Project	IEEE 802.16 Broadband Wireless Access Working Group < http://ieee802.org/16 >	
Title	Backward Compatibility of CSI Mechanism	
Date Submitted	2007-01-04	
Source(s)	Wu Xuyong, Huawei Huawei Industrial Base, Bantian, Longgang, Shenzhen 518129 P.R.C	Voice: +86-755-28972327 Fax: wuxuyong@huawei.com
Re:	80216h-06_028 : Title: TGh Report closing plenary- Meeting 46 (2006-11-17)	
Abstract	Discuss the backward compatible CSI mechanism.	
Purpose	To consolidate the 16h draft.	
Notice	This document has been prepared to assist IEEE 802.16. It is offered as a basis for discussion and is not binding on the contributing individual(s) or organization(s). The material in this document is subject to change in form and content after further study. The contributor(s) reserve(s) the right to add, amend or withdraw material contained herein.	
Release	The contributor grants a free, irrevocable license to the IEEE to incorporate material contained in this contribution, and any modifications thereof, in the creation of an IEEE Standards publication; to copyright in the IEEE's name any IEEE Standards publication even though it may include portions of this contribution; and at the IEEE's sole discreti

Table-h5 CSI symbol Format

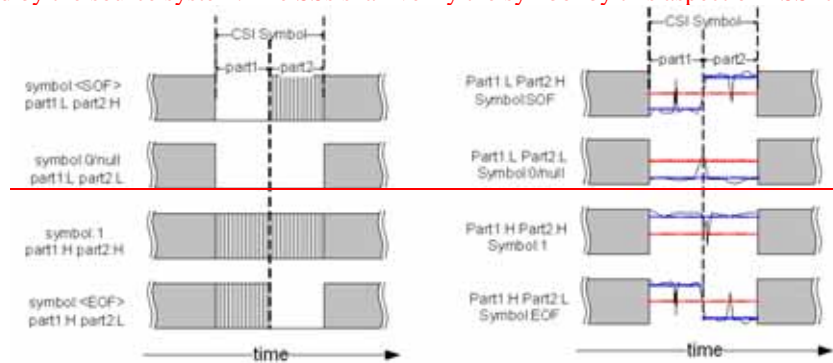
The format of each of the four kinds of symbols is shown in the table below:

format		signification
Part1	Part2	
L	H	$\langle \text{SOF} \rangle$
H	L	$\langle \text{EOF} \rangle$
L	L	0
H	H	1

Figure h32- **Timing of CSI bit unit symbol transmission and receiving**

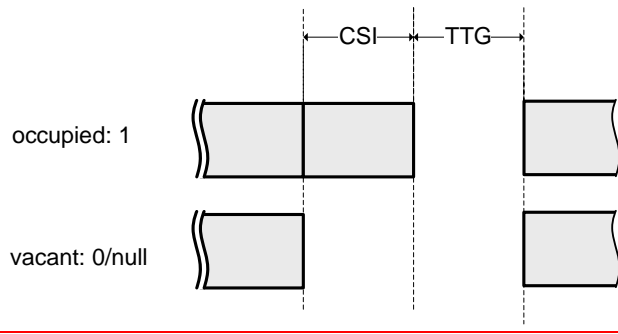
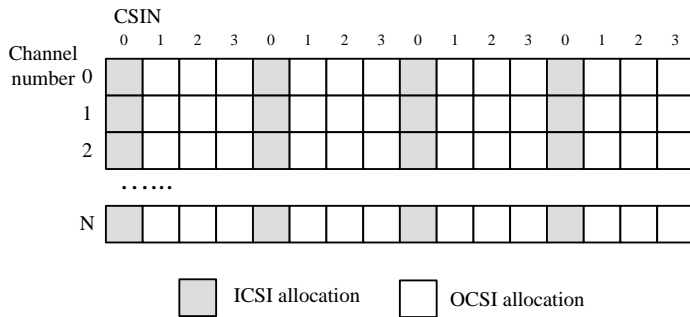
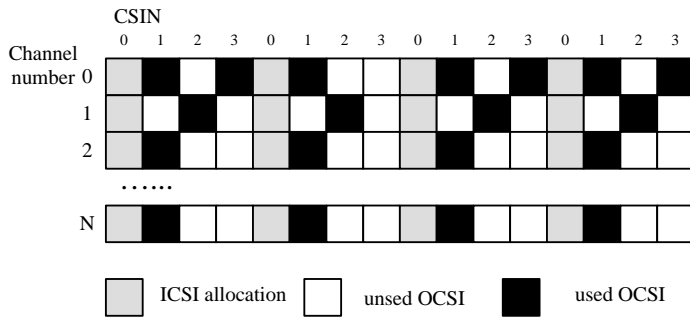
For the transmission side (BS), to use CSI duration as part of the data burst and continues to transmit indicates bit one, while to stop transmission at the beginning of CSI duration indicates bit zero. (See figure hxx. below) While the receiver side is using the signal strength during the CSI duration to decode the carried bit, in periodical CSI slots allocated for each transmitter, the receiver is de facto demodulate energy keying or so called on/off keying signal. The detail of the receiving algorithm is out of the scope of this standard.
